**Re: Petition 1347A - GRE GACRUX LLC Petition for a Declaratory Ruling, Pursuant to Connecticut General Statutes §4-176 and §16-50k, for the Proposed Construction, Maintenance and Operation of a 16.78 MW AC Solar Photovoltaic Electric Generating Facility Located at 117 Oil Mill Road and Associated Electrical Interconnection to Eversource Energy's Existing Substation at 325 Waterford Parkway North in Waterford, Connecticut. Reopening of this Petition Based on Changed Conditions Pursuant to Connecticut General Statutes §4-181a(b).**

**Petition No. 1347A**

**GRE GACRUX LLC'S RESPONSES TO THE CONNECTICUT  
SITING COUNCIL'S FIRST SET OF INTERROGATORIES**

© 2018 RL COMPANIES, INC. THESE DRAWINGS SHALL NOT BE UTILIZED BY ANY PERSON, FIRM OR CORPORATION WITHOUT THE SPECIFIC WRITTEN PERMISSION OF RL COMPANIES, INC.

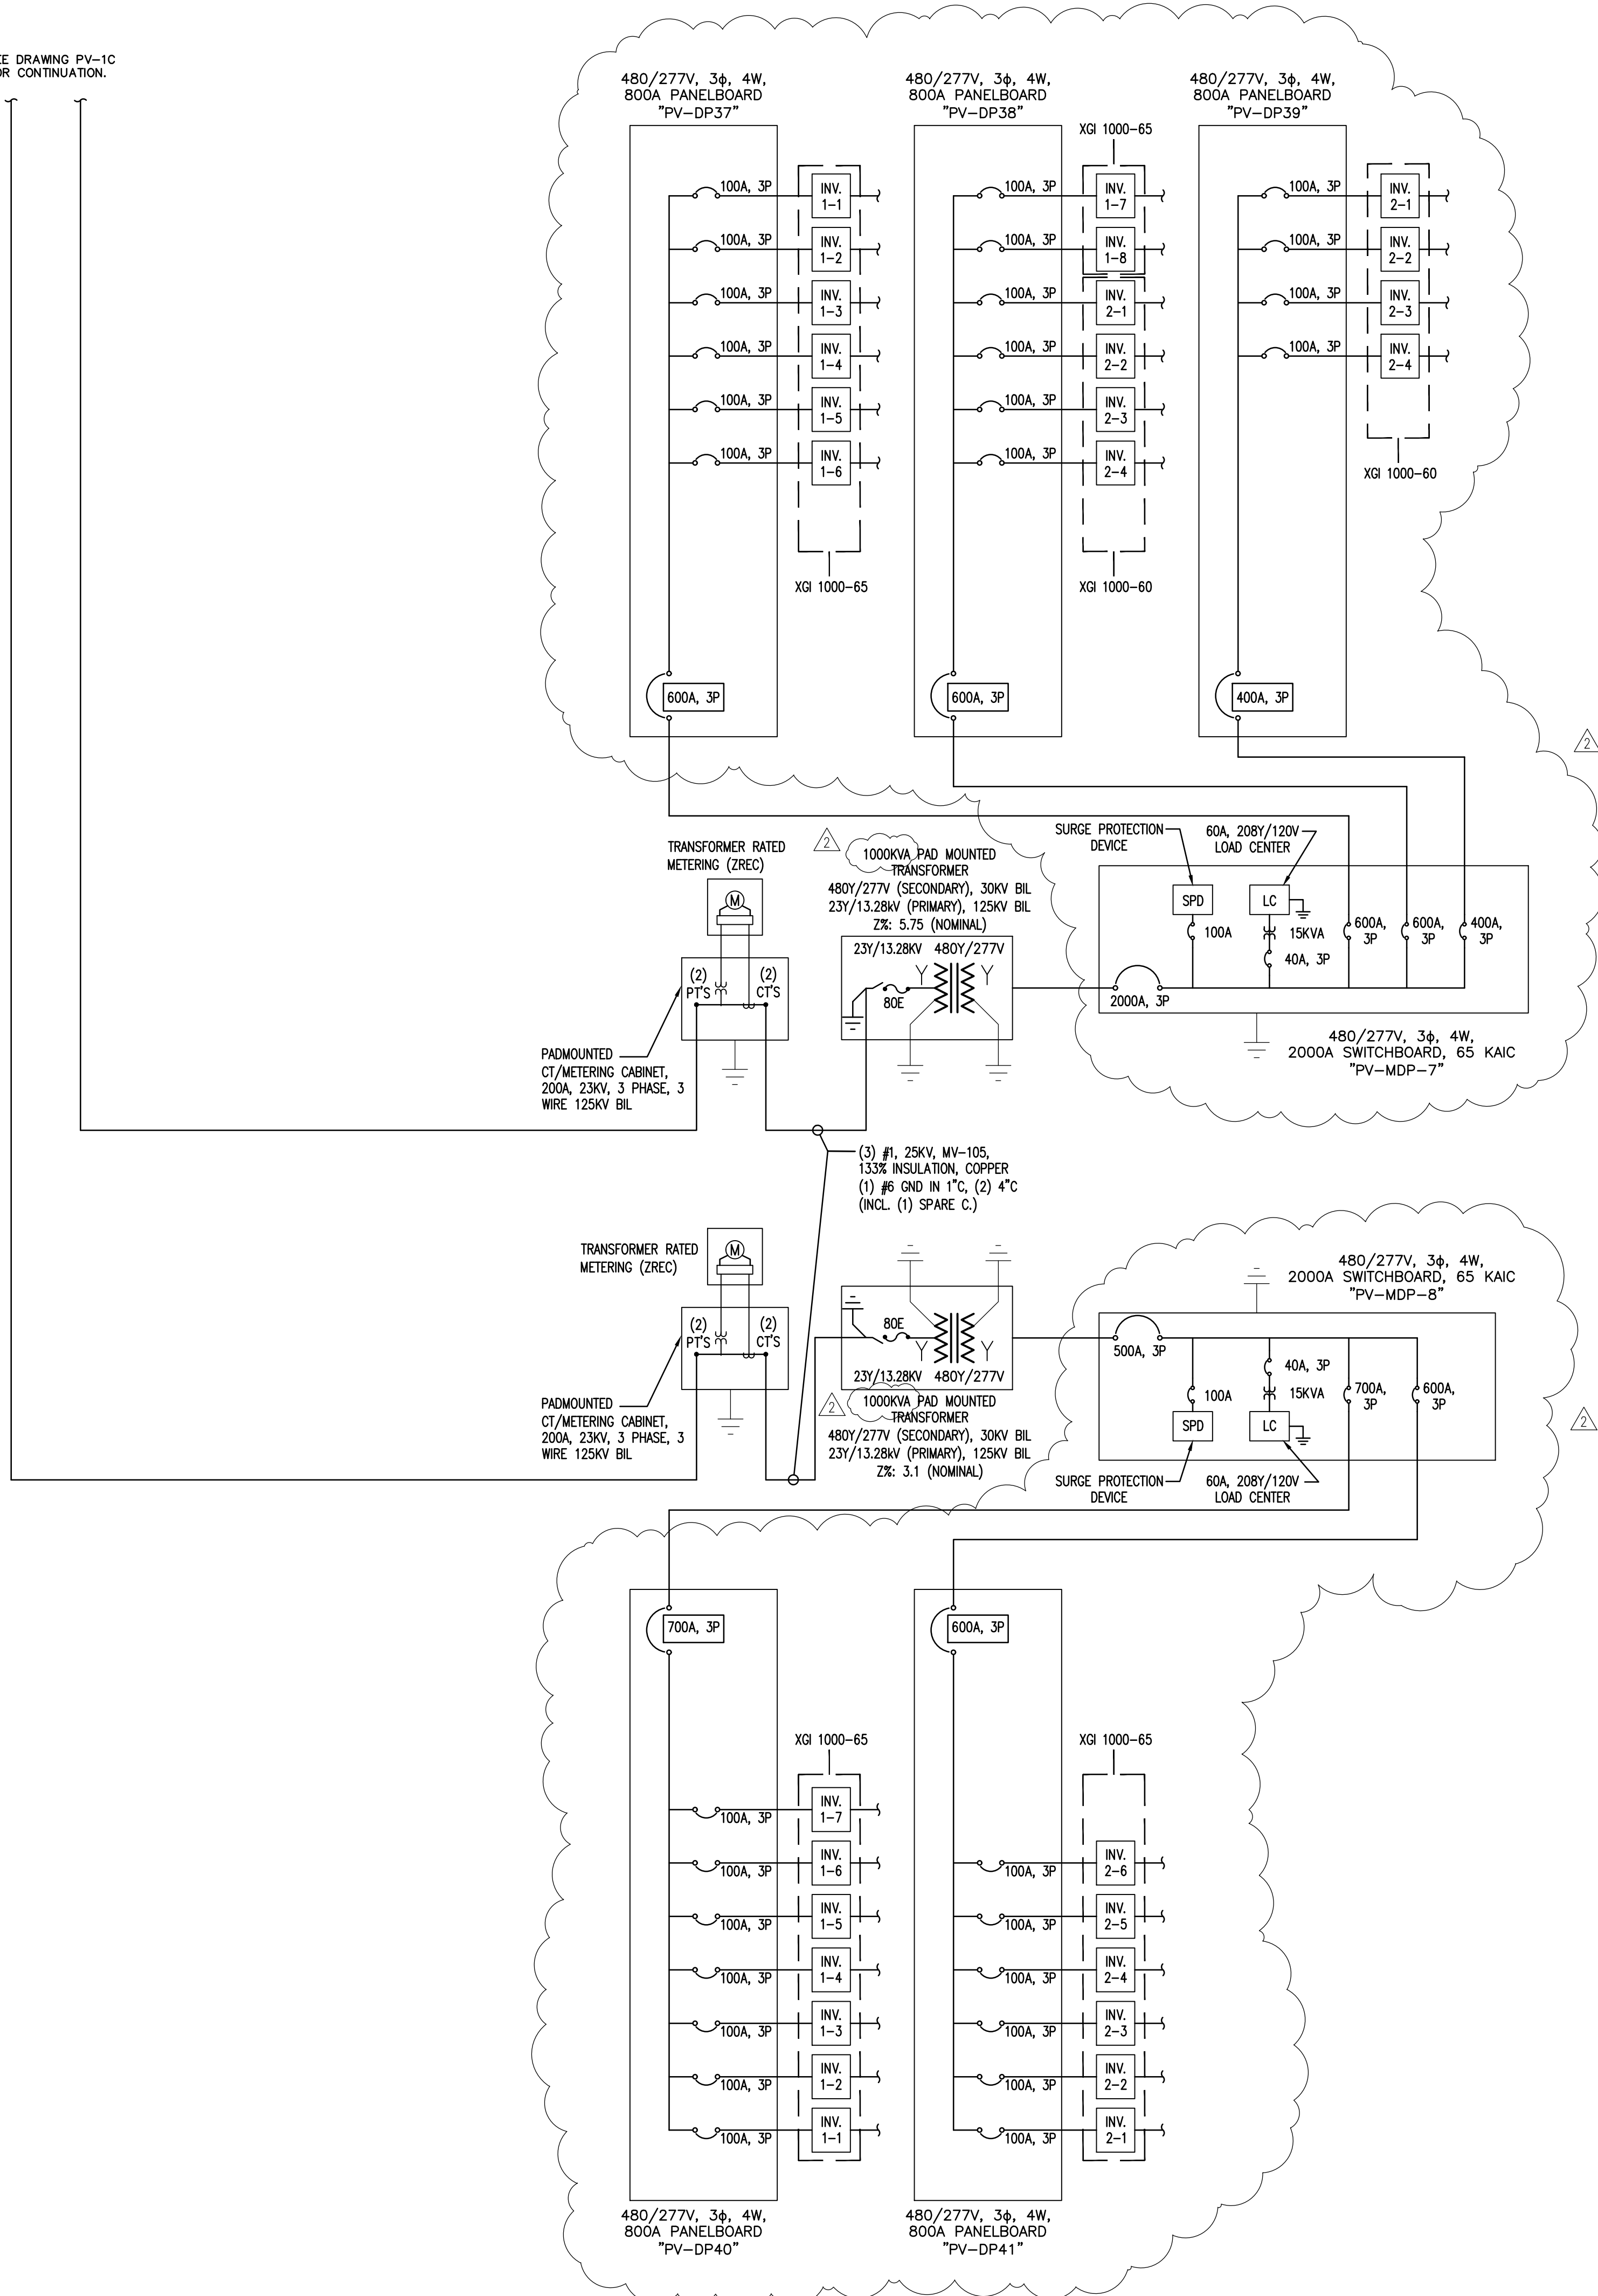
29. The hard copy version of the Petition Appendix A contains a PV Site Plan series that was not submitted in .pdf format. Provide a .pdf version of the PV Plan series.

A .pdf version of the PV Plan series is included herein as Exhibit F.
